SUBJECT: Submits response to NRC 980518 RAI re submittal for Leak-
 Before-Break approval for portions of RHR sys.

Subject: Response to Request for Additional Information (RAI) Related to Leak-Before-Break
(TAC No. MA0389)
R. E. Ginna Nuclear Power Plant
Docket No. 50-244

**Responses to U.S. NRC Request for Additional
Information Regarding Request Leak-Before-Break
Approval Portions of the
R.E. Ginna Nuclear Power Plant
Residual Heat Removal System Piping (TAC MA0389)**

Figure 1. J-R Resistance Curve for Type 316 Stainless Steel [2]

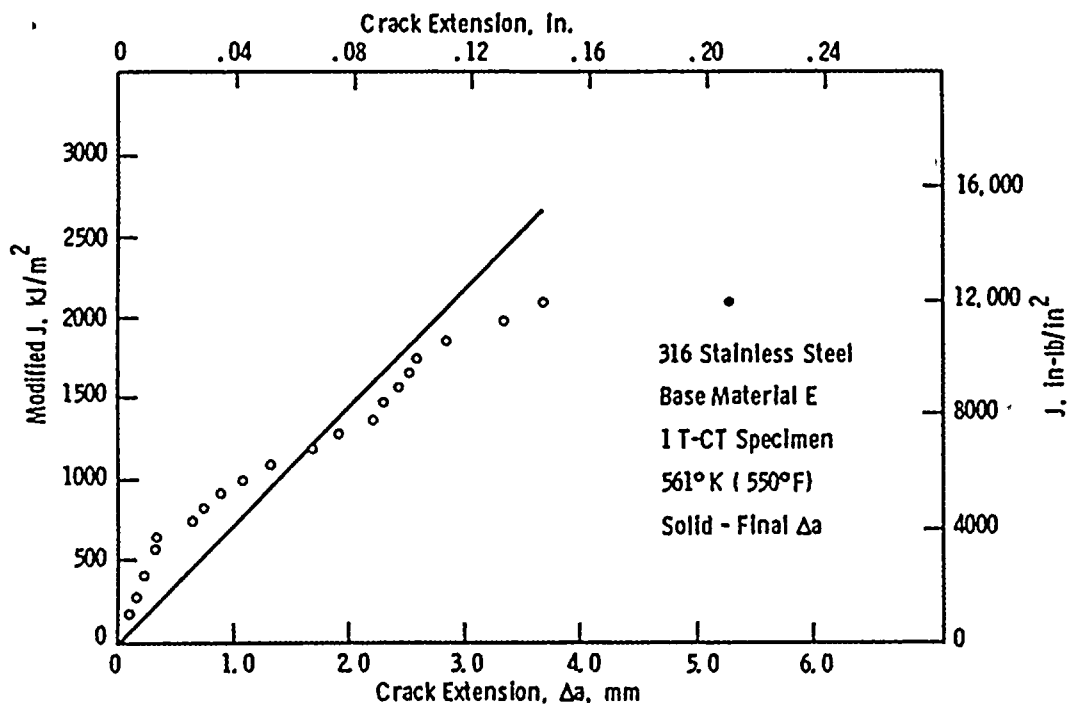
The information in Section 4.2 of the SI report indicated that ASME Code values were used for the Young's Modulus, yield strength, and ultimate strength. However, as noted in Section 5.2 of NUREG-1061, Vol. 3, when performing LBB analyses, an emphasis is placed on obtaining and using materials data from specimens manufactured from the actual piping and weld materials used in the facility.

Confirm that no materials test data exists for the Ginna RHR piping or weld materials from the time of facility fabrication. If no data exists, demonstrate when calculating the margin between the leakage flaw size and the critical flaw size that the use of ASME Code minimum values provides a bounding analysis when compared to the use of typical values for the yield and ultimate strengths for Type 316 stainless steel.

for this purpose, the J-R curve provided in Reference 2 was used. This J-R curve is shown in Figure 1. As can be seen from this figure, the maximum crack extension associated with this J-R curve is 0.2 inches with a corresponding J of 12 in-k/in². In addition, the welds of the Ginna RHR piping were fabricated using SMAW welding (Reference 6). Hence the properties of SMAW weldments provided in EPRI Ductile Fracture Handbook and shown in Table 1-3 were also used to calculate the critical flaw size. The results of the analyses are provided in Table 1-4. It can be seen that the use of the alternate material properties for the Type 316 stainless steel resulted in very comparable results to those obtained in SIR-97-077 with the two alternate set of properties resulting in slightly larger critical flaw sizes. The leakage through half the critical flaw size was recalculated for the most limiting critical flaw size (Node 680 on the hot leg) using the generic Type 316 stainless steel and SMAW properties and was found to be at least 5.0 gpm compared to 4.71 gpm obtained using the Code minimum properties in SIR-97-077, Rev. 0. In all cases, the leakage is within the detectable limits at Ginna as explained in Response to Question No. 6.

Figure 7-1. Determination of Critical Flaw Size Nuclear Remote Tension for Node 680

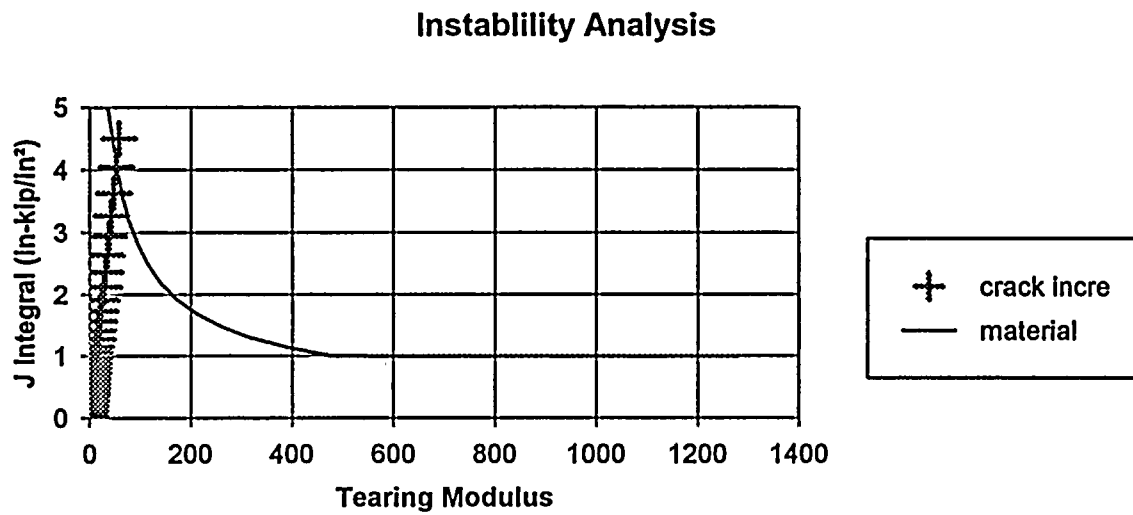
Provide additional explanation regarding the criteria used to determine the critical flaw size for each location in the analysis. In particular, explain what is meant by the statement beginning on page 5-2, "Crack extensions during stable ductile tearing in the EPFM analyses are conservatively not included in the critical flaw length computations." Does this imply that stable crack growth beyond J_{IC} is not included in the determination of the critical flaw size?

The J-Integral/Tearing modulus evaluation methodology which considers stable ductile tearing beyond J_{IC} was used to determine the critical flaw sizes. The J-R material resistance curve presented in Table 4-1 of SIR-97-077 was converted to a J-T material curve where the Tearing Modulus (T) is defined as:

where dJ/da is the slope of the J-R curve, E is the modulus of elasticity and σ_o is the reference stress (assumed to be the flow stress). The applied J versus a curve is also converted into a J-T curve. The intersection of these two curves represents the point of instability and the crack size at this instability point is the critical flaw size. An example of the critical flaw size determination is shown in Figure 7-1.

The statement "Crack extensions during stable ductile tearing in the EPFM analyses are conservatively not included in the critical flaw length computations" on page 5-2 in the report is misleading and is subsequently clarified above.

Figure 9-1. Comparison of Solution for Critical Flaw Size Using Exact Solution for Combined Tension and Bending With Linearly Interpolated Values ($n = 5$)

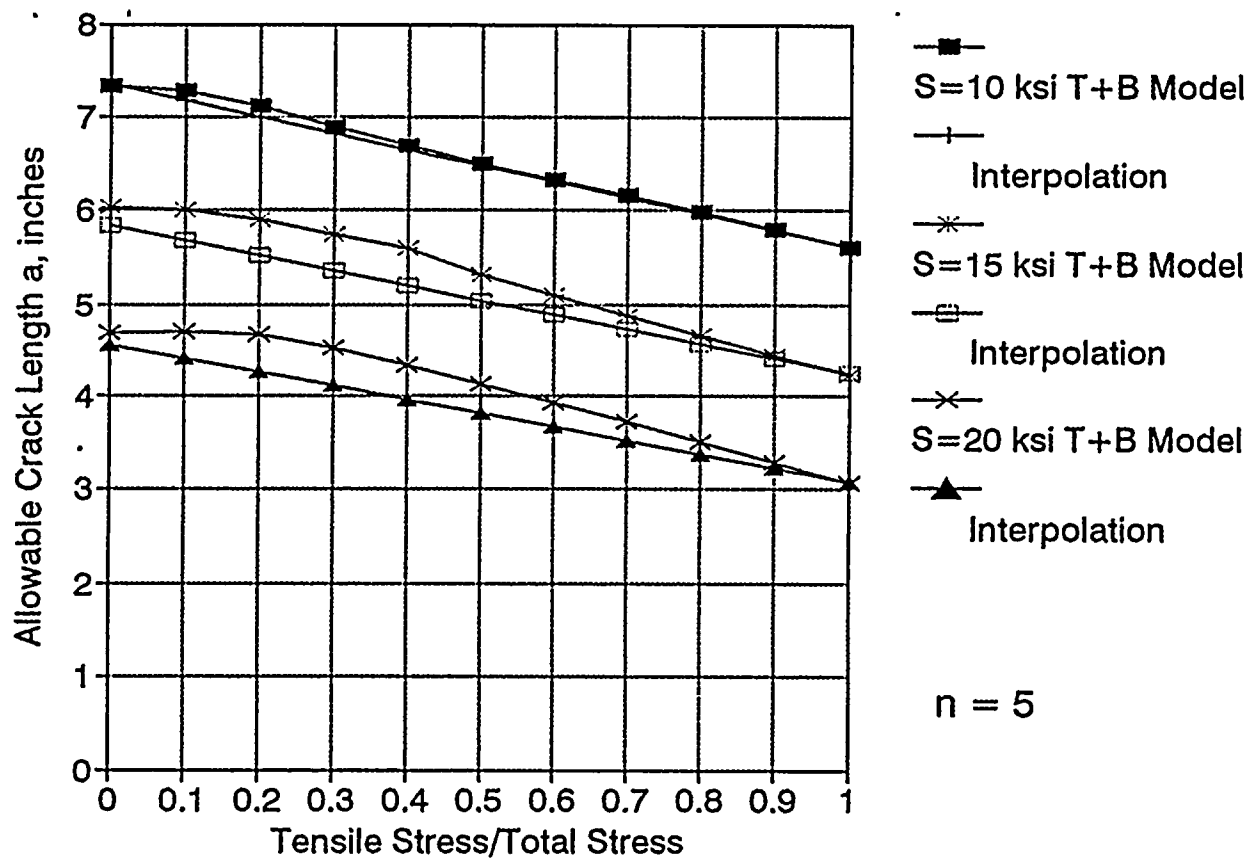
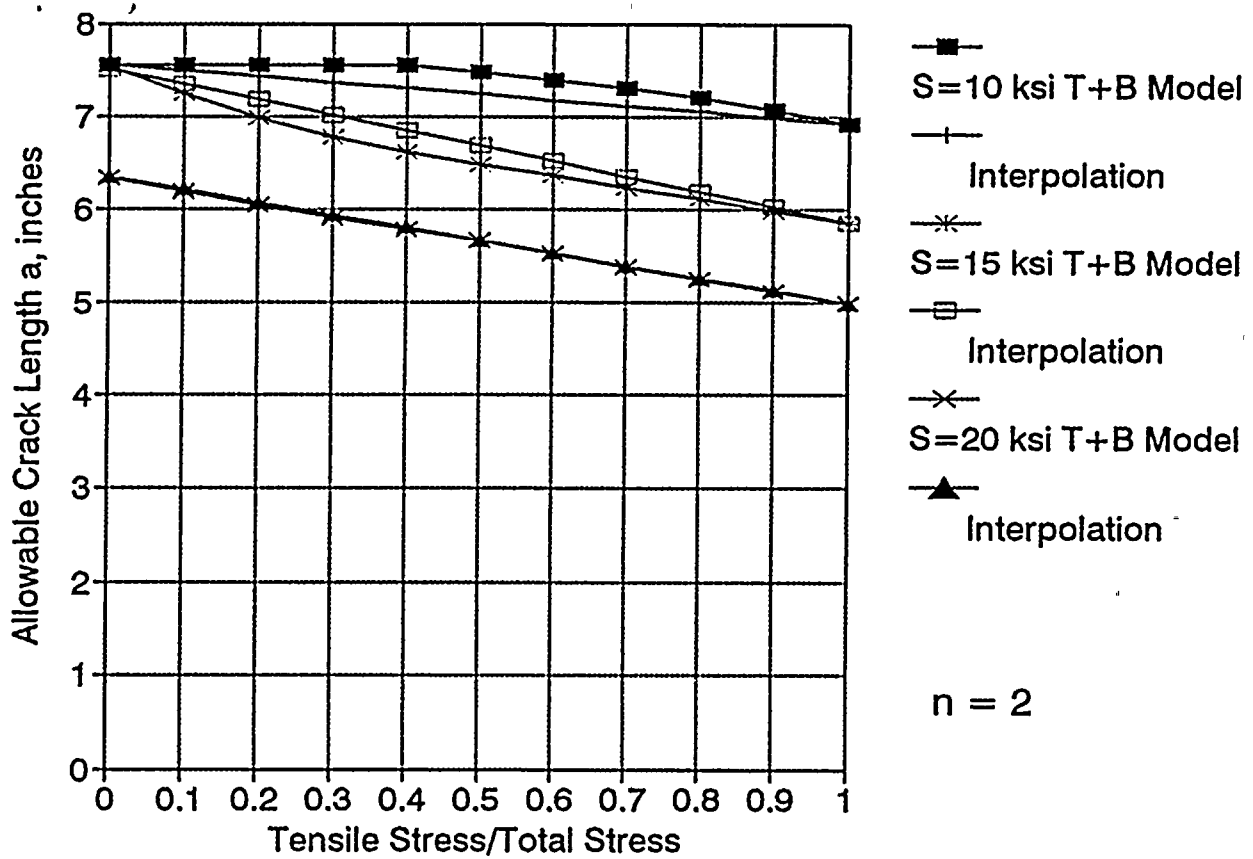
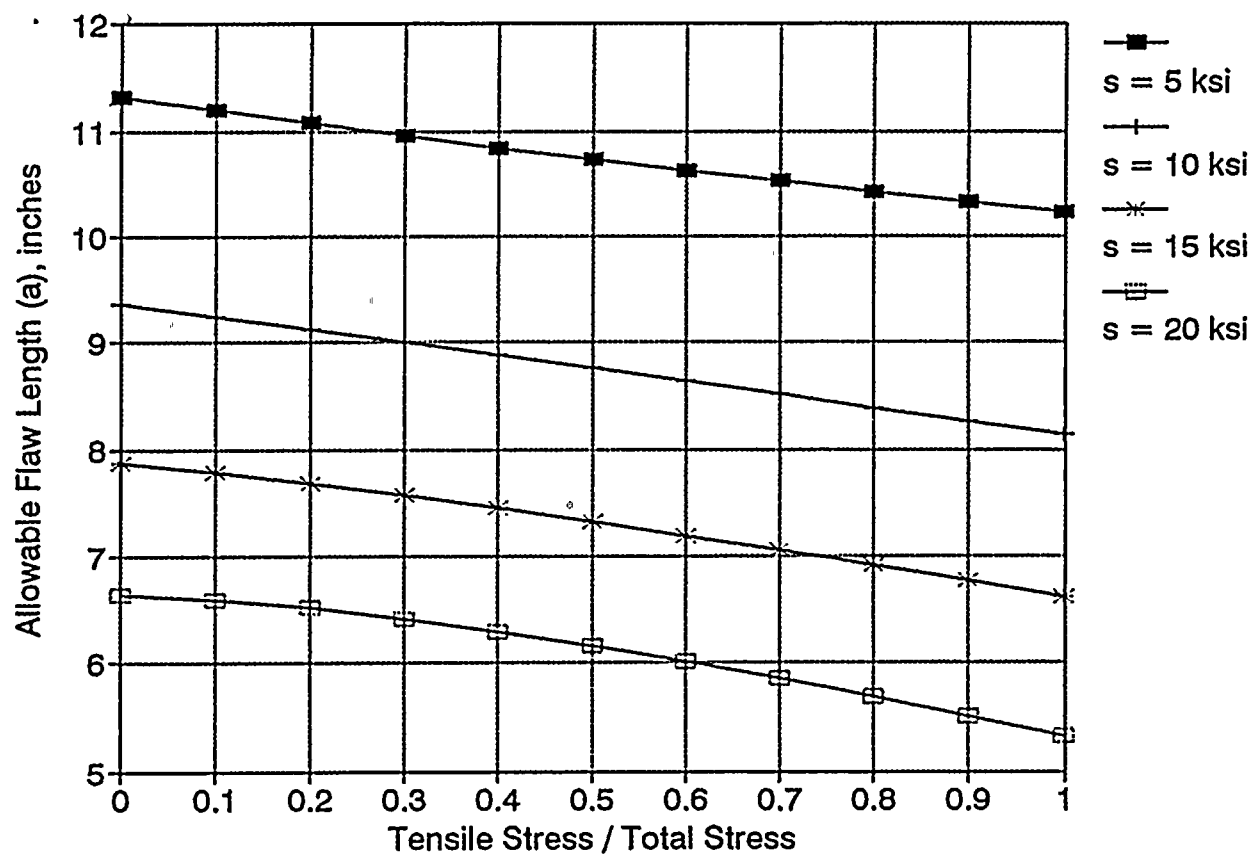
Given that you have calculated a critical flaw under simple tension loading and under simple bending loading scenarios, justify the technique (shown in the top equation on page 5-3 of the SI report) used to determine the final critical flaw size by linear interpolation of your tension loading and bending loading solution. Demonstrate that this method provides either an exact solution for the critical flaw size under combined loading or that conservatively estimates the critical flaw length or submit a reference in which this is demonstrated.

Alternate models for circumferential through-wall flaws under remote tension, remote bending and combination of tension and bending are provided in the EPRI Ductile Fracture Handbook (Reference 1). Solutions are provided in this handbook for pipe radius to thickness (R/t) ratios of 5, 10 and 20 for the remote tension and remote bending cases. However, for combined tension and bending cases, solutions are provided only for R/t = 10 which is different for the piping geometry at Ginna. It is for this reason that the simple linear interpolation scheme in SIR-97-077 was used. To determine the reasonableness of this approach, the models in the EPRI handbook for R/t = 10 were used to determine the critical flaw sizes for remote tension, remote bending and various combination of the tension and bending stresses. The parameters used for the evaluation are:

The results are presented in Figures 9-1 and 9-2 for combined stresses of 10, 15 and 20 ksi. In these figures "T + B" refers to the combined tension and bending solution from the EPRI handbook and "Interpolation" refers to the linear interpolation scheme used in SIR-97-077, Rev. 0. It can be seen that in all cases the critical flaw sizes obtained using the linear interpolation scheme in SIR-97-077, Rev. 0 is bounded by that obtained using the combined tension and bending model or very closely matches it. For the cases where the stresses were assumed to be either all remote tension or bending, the critical flaw sizes obtained with the **pc-CRACK** program matched those obtained using the alternate model from the EPRI Ductile Fracture Handbook.

To further illustrate the reasonableness of the linear interpolation scheme, limit load solution provided in ASME Section XI technical basis document (Reference 3) was used to determine the allowable through-wall crack length under various combination of tension and bending stresses. In this evaluation, a pipe with outside diameter of 10.75 inches and flow stress of 51 ksi was used. *Z* factor consistent with that in Reference 3 for SMAW material was used. The results of the analysis are shown in Figure 9-3. It can be seen that in this case also, linear interpolation of the pure tension and bending cases gives conservative results compared to the actual combined tension and bending solution shown in Figure 9-3.
